**CALIFORNIA REGIONAL WATER QUALITY CONTROL BOARD
LAHONTAN REGION**

SUBJECT: **WASTE DISCHARGE REQUIREMENTS, TOWN OF APPLE VALLEY AND VICTOR VALLEY WASTEWATER RECLAMATION AUTHORITY; APPLE VALLEY SUB-REGIONAL RECLAMATION PLANT, SAN BERNARDINO COUNTY**

**WASTE DISCHARGE REQUIREMENTS AND
WATER RECYCLING REQUIREMENTS
FOR THE
TOWN OF APPLE VALLEY AND VICTOR VALLEY
WASTEWATER RECLAMATION AUTHORITY
APPLE VALLEY SUB-REGIONAL RECLAMATION PLANT**

RESPONSE – BOARD ORDER NO. R6V-2013-00-(TENTATIVE), APPLE VALLEY SUB-REGIONAL RECLAMATION PLANT, PRODUCER/DISCHARGER, APPLE VALLEY, SAN BERNARDINO COUNTY

Figure 1. Mixing model results

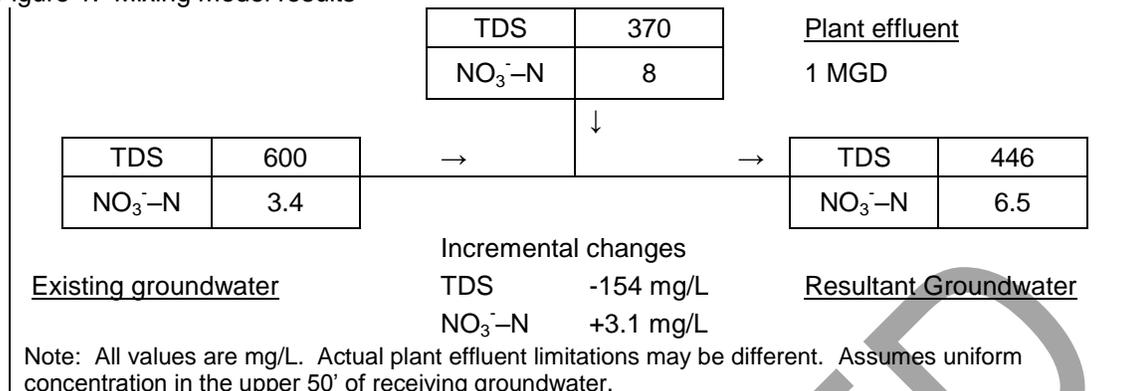
This statement contradicts the mixing model discussion on page 7, which describes existing groundwater quality conditions have a TDS concentration of about **600 mg/L** and a **NO₃-N** concentration of **3.4 mg/L**. These estimated background groundwater quality concentrations are based on the Producer/Discharger’s Title 22 Engineering Report (Revised) referenced on page 7. The background TDS and nitrate-nitrogen concentrations should be corrected on p. 6 to match the values in Figure 1 on p. 7 (i.e., 600 mg/L for TDS and 3.4 mg/L for NO₃-N). The values in Figure 1 are based on a more recent analysis provided with VVWRA’s letter dated July 20, 2012 and these TDS and NO₃-N values more closely represent the local groundwater quality.

The 50 ft/day parameter describes the hydraulic conductivity not the hydraulic gradient. Other language in this discussion needs clarification. It is requested that the above description be revised to read: "The model involves a complete mixing column, an estimated hydraulic conductivity of 50 ft/day, and the local groundwater gradient. The mixing column includes the upper part of the aquifer, particularly a thickness extending to 50 feet below the water table, or saturated zone, and a ½ mile radius from the land discharge site."

than 3.1 mg/L although the resulting groundwater would be less than 6.5 mg/L shown in Figure 1. Nevertheless, the conclusions of the maximum benefit principle are the same because the Discharger would need to install reverse osmosis to keep the discharge from increasing existing groundwater quality.
